Permit Revision Submittal Requirements and Application

Description of Revision

Panel layout changed during install per Homeowner request

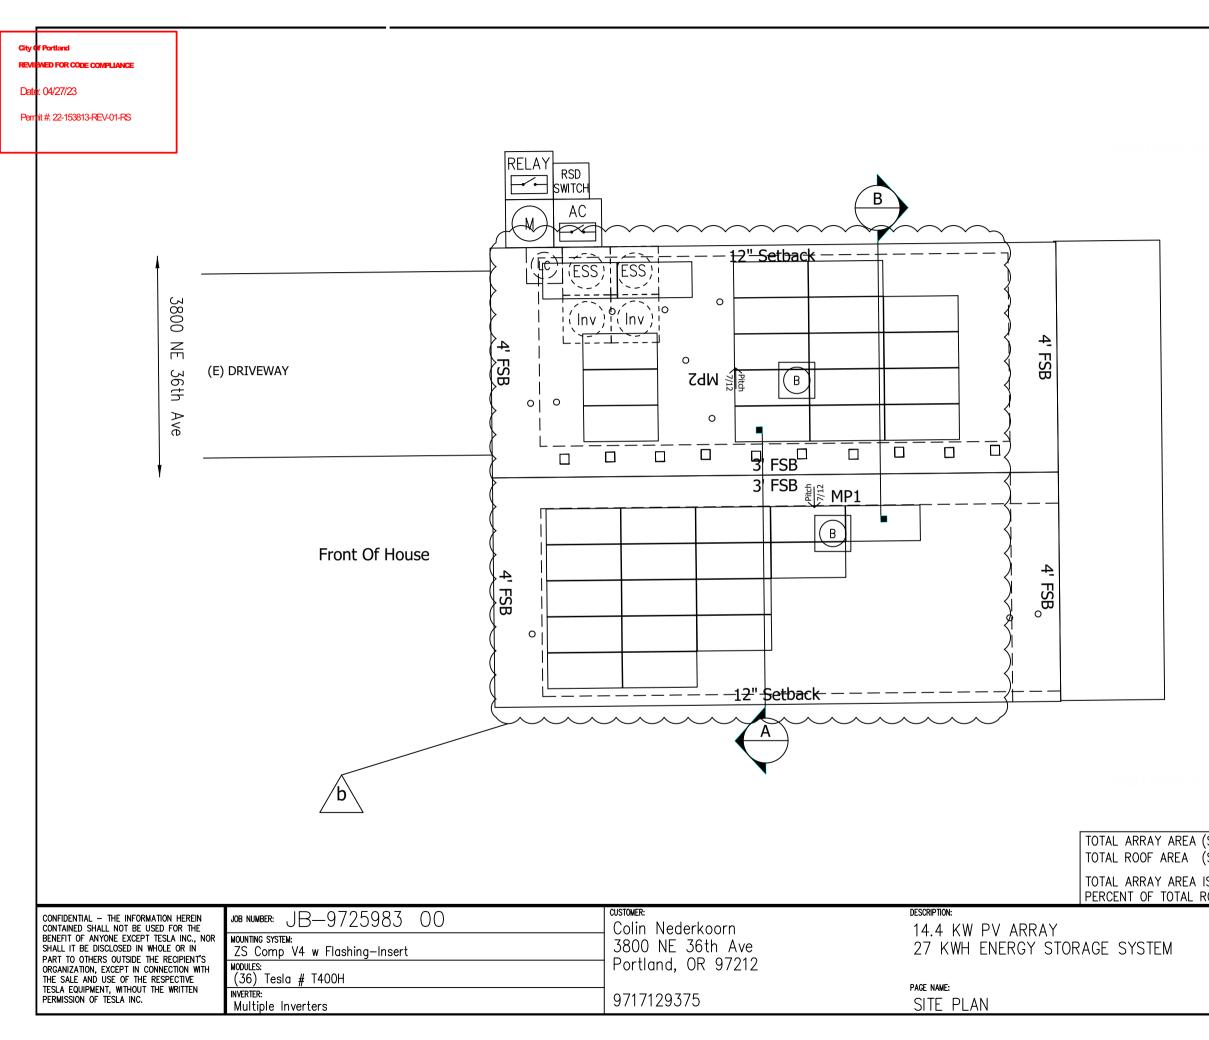
INDEX
	Sheet 1 COVER SHEET Sheet 2 PROPERTY PLAN Sheet 3 SITE PLAN Sheet 4 STRUCTURAL VIEWS Sheet 5 UPLIFT CALCULATIONS Sheet 6 ELEVATION Sheet 7 THREE LINE DIAGRAM Cutsheets Attached				
No	WEP	REV	BY	DATE	COMMENTS
Me	<u> 1111</u>	REV A	IF	6/23/22	Site plan updated
SU	IRE	REV B	TG	2/22/2023	adjusted layout to avoid shade
Sou		*	*	*	*
ACI	GEO	*	*	*	*
AG	020	*	*	*	*
	DESIGN: Taylor (SHEET:	REV:	DATE:		TISLI
		В	2/2	22/2023
